**Agenda**  
**City of Springboro Planning Commission Meeting**  
**Wednesday, January 10, 2024, 6:00 p.m.**  
**Council Chambers, City Building, 320 West Central Avenue**

**Background Information & Staff Recommendation**  
**City of Springboro Planning Commission Meeting**  
**Wednesday, January 10, 2024, 6:00 p.m.**  
**Council Chambers, City Building, 320 West Central Avenue**

**Site Plan Review, 3300 West Tech Road, medical office space for Dayton Children's South Campus Behavioral Health**

RECORD PLAN  
Clearview Crossing  
At Stone Ridge

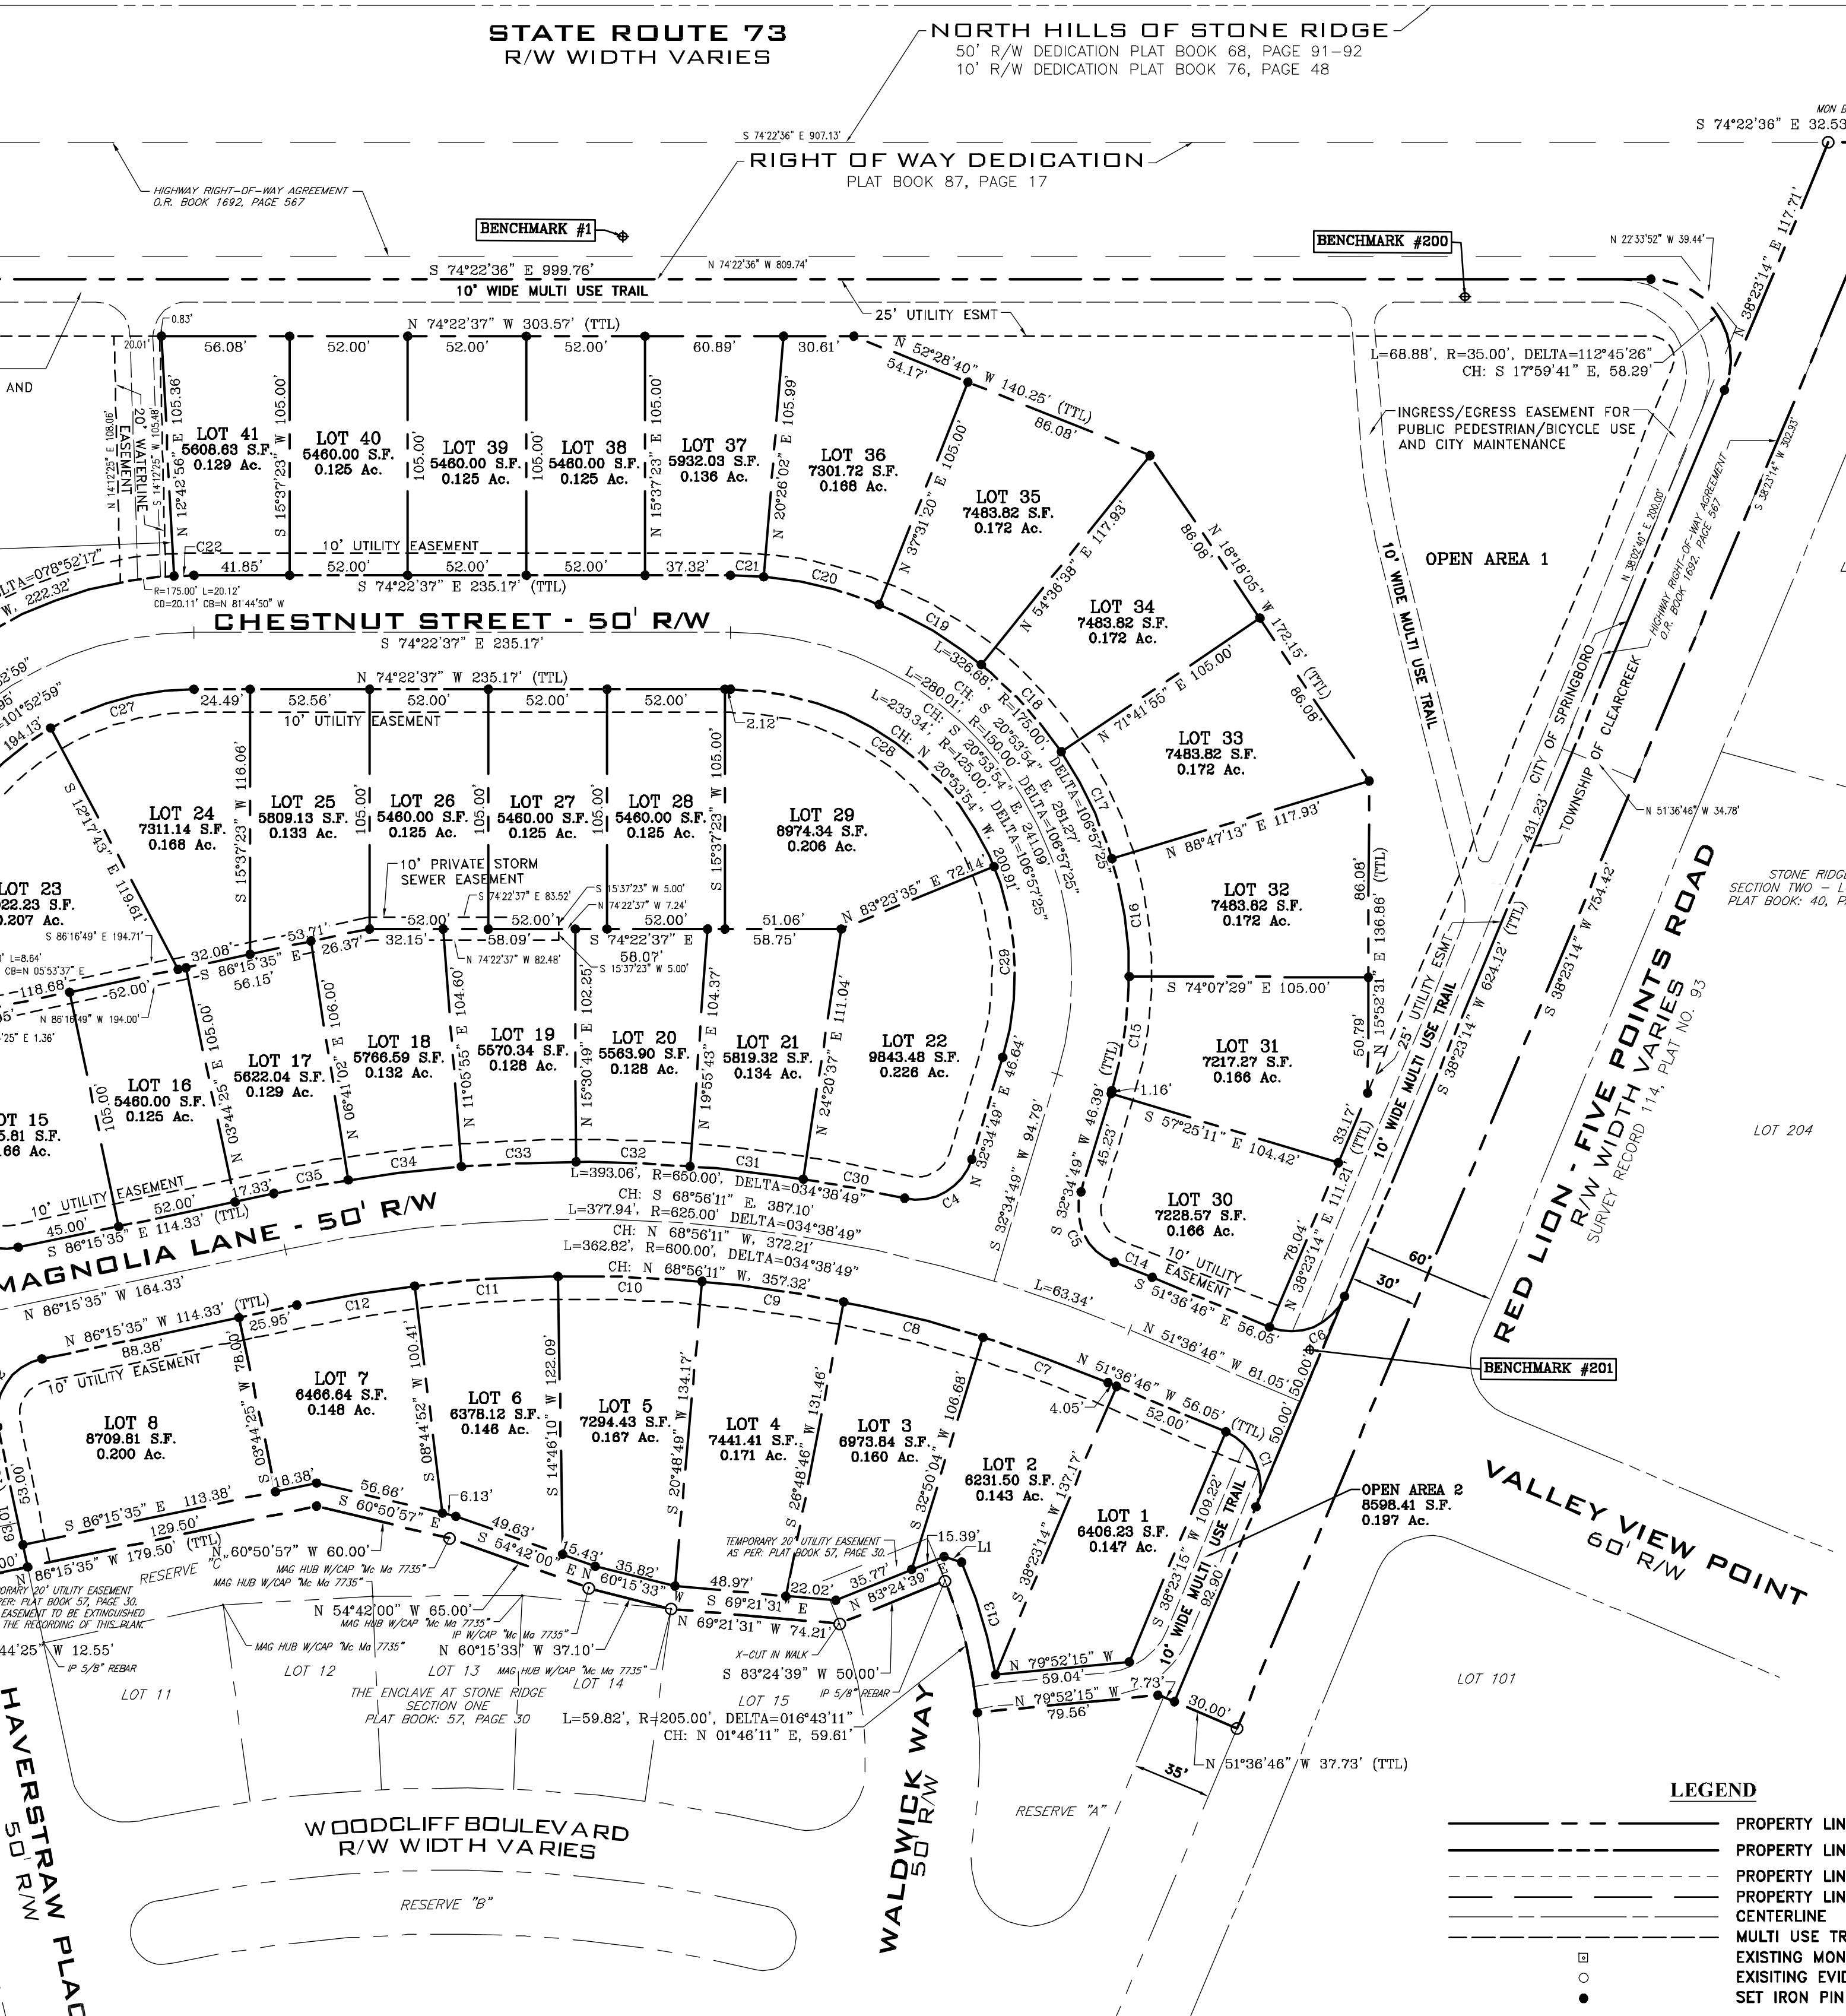
1. Clearly delineate ingress/egress easement (metes/bounds) for the multiuse path – which is to be maintained by HOA. Revise plan accordingly. Or possibly add note stating that the Open Areas 1 and 2 are subject to an ingress/egress easement for the path and for path maintenance purposes.
2. Add street name Haverstraw Place for the portion of the road being platted south of Magnolia Lane.
3. Add note stating all lots shall have a post light with photoelectric cell, and shall be maintained in working order at all times.
4. Add note stating all lots shall be subject to a publicly available drainage easement of 5 feet in width along all side yards and 10 feet along rear lot lines, unless otherwise indicated.
5. Submit to Warren County for review and make appropriate revisions, if any.
